Contract #: 04-0120F4Cty: SF/ALA Rte: 80 PM: 13.2/13.9File #: 69.25B**QUALITY ASSURANCE -- NON-CONFORMANCE REPORT****Location:** Changxing Island, Shanghai, P.R. China**Report No:** NCR-000617**Prime Contractor:** American Bridge/Fluor Enterprises, a JV**Date:** 09-Jan-2010**Submitting Contractor:** Zhenhua Port Machinery Company, Ltd (ZPMC), Changxing Island**NCR #:** ZPMC-0590**Type of problem:**

Reference Description: Missed MT Indication by QC on 5AW Deck Panel**Description of Non-Conformance:**

Dear: Mr. Charles Kanapicki
Job Name: SAS Superstructure

Subject: NCR No. ZPMC-0590

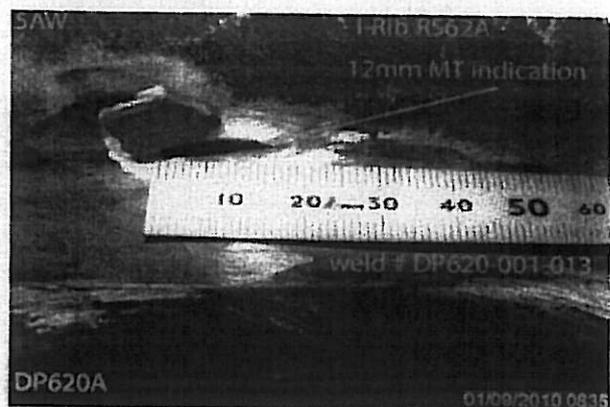
During the Quality Assurance Magnetic Particle Testing (MT) review of welds located on Segment 5AW, this Quality Assurance Inspector (QA) discovered the following issues:

-One (1) Longitudinal linear indication measuring approximately 12mm in length.

-The weld is identified as: DP620-001-013.

-This Fillet Weld joins I-Rib RS62A to Deck Plate DP620A in Corner Assembly CA15A.

-These welds are designated as Non-Seismic Performance Critical Member (SPCM).

The Notice of Witness Inspection Number (NWIT) is 005016. The indication is located inside the area that has been previously tested and accepted by ZPMC Quality Control (QC) personnel.

Draft of Welding Discontinuity:

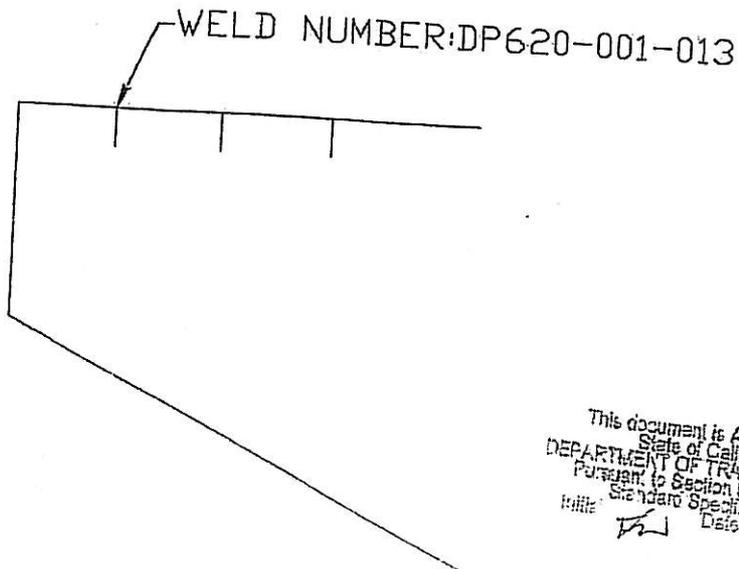
在对DP620-001-013检测时, 发现1处纵向裂纹. L1=10mm

One longitudinal crack was found by use of MT on DP620-001-013.

1. 火焰加热时, 水汽没有完全的去掉或者这个区域预热不够;
1. Moisture wasn't completely removed during drying operation (preheating) or the area wasn't preheated sufficiently.

12. 在焊缝冷却至环境温度至少经过48小时以后进行NDT检查;
 13. 返修后根据图纸进行MT检测, 并按照合同10-1.59 “钢结构” 中的“检测和试验” 要求进行附加MT检测。对于CJP焊缝, NDT为VT, MT和UT。
1. QC and a Lead CWI shall be present, direct and supervise all grinding and welding operations during this repair to ensure the repair is per the disposition requirements

2. QC and a Lead CWI shall have an approved copy of the CWR in hand prior to the repair.
 3. Remove paint ≥ 25 mm in all direction of HAZ prior to MT.
 4. Clean the excavation area of all loose debris including MT powder. Preheat to 65° C before removing cracks by grinding, repair area shall extend a minimum of 50mm beyond each end of single crack repairs.

5. If base metal is damaged by grinding, the damaged area shall be ground clean prior to performing weld repair. If gap > 5mm is found during or after grinding, comply with the notification on changing fillet weld to CJP which is submitted for Engineer's review and approval form.

6. Prepare excavation in accordance with the New Repair Procedure prior to welding.
 7. Before this repair, Verify with VT and MT repair areas are defects free, and also MT shall be performed on the base metal laying abroad cracks to ensure that no cracks were propagated to the base metal. Separate CWR approval is needed if cracks are found in the base metal, and only after this new CWR's approval can continue the repair.

8. Clean excavation area of all loose debris including MT powder after excavation. Preheat and weld according to repair WPS, the preheat shall between 160° C—230° C.

9. Perform post weld heating according to repair WPS, the postheat shall between 230° C—315° C and for one hour minimum.
 10. Allow the weld to cool to ambient temperature gradually. Control cooling rate after PWHT to no more than 50° C per hour.

11. Grind the repaired area flush with base metal or the adjacent weld after post weld heating.
 12. Wait 48 hours at least after the repair area has cooled to ambient temperature before performing NDT.

13. Perform MT inspection to all repair area according to Contract Drawings along with all additional NDT required by the applicable notes Special Provision Section 10-1.59 'Steel Structure', subsection: 'inspection, testing'. NDT include VT, MT and UT if it is a CJP weld.
